UNITED STATES
NUCLEAR REGULATORY COMMISSION
OFFICE OF INSPECTION AND ENFORCEMENT
WASHINGTON, DC 20555

IE Bulletin 79-05B

NUCLEAR INCIDENT AT THREE MILE ISLAND - SUPPLEMENT

Figure 1

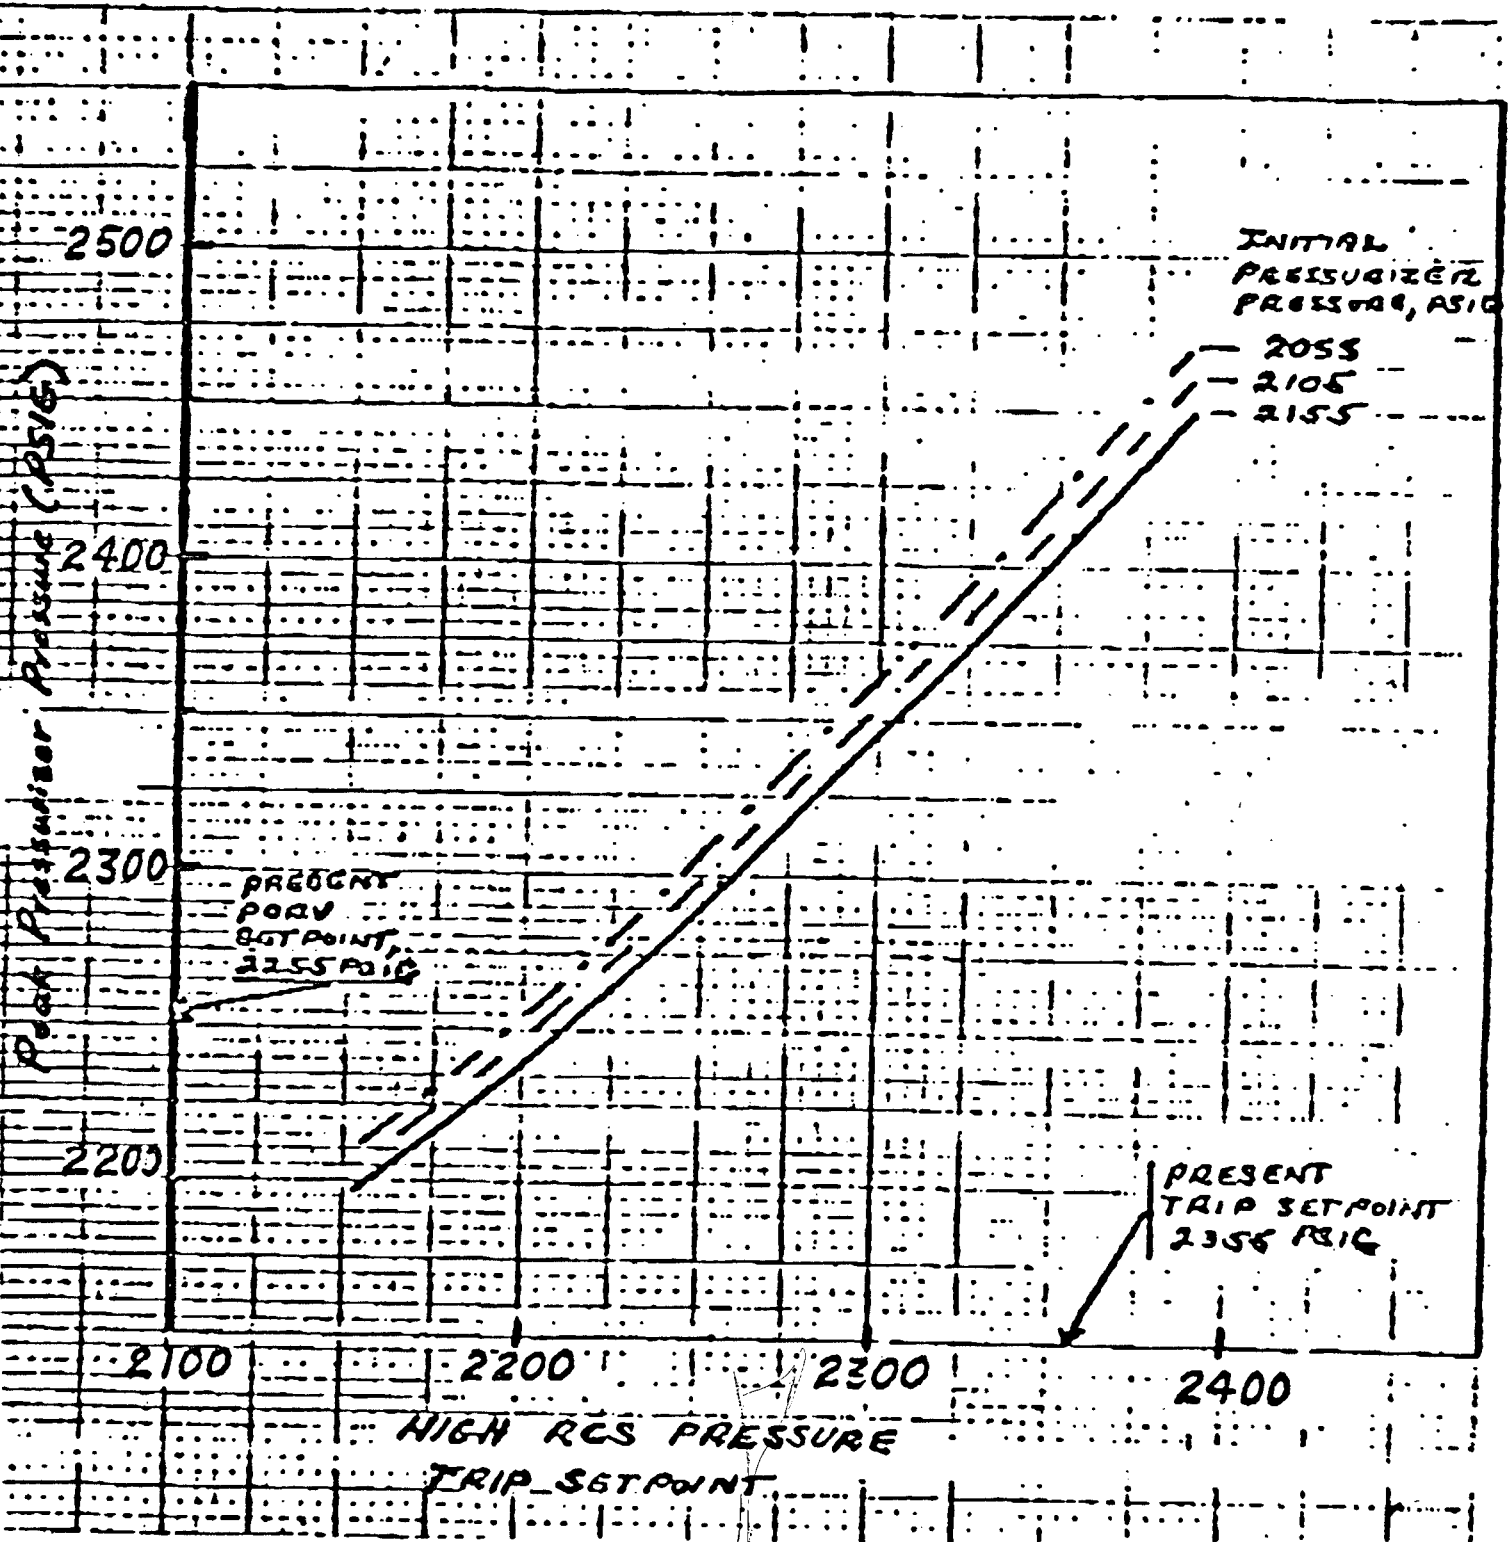
The effect of changing the reactor coolant system pressure trip setpoint upon peak pressurizer pressure is typified by the attached figure 1, which was developed by B&W for a loss of feedwater transient.

Peak pressurizer pressure as a function of RCS pressure trip setpoint for a loss of feedwater transient for expected conditions and various initial pressures.

LOWERING THE HIGH PRESSURE REACTOR TRIP SETPOINT FROM 2355 PSIG TO 2300 PSIG

RAISING THE SETPOINT FOR THE PILOT OPERATED RELIEF VALVE FROM 2255 PSIG TO 2450 PSIG
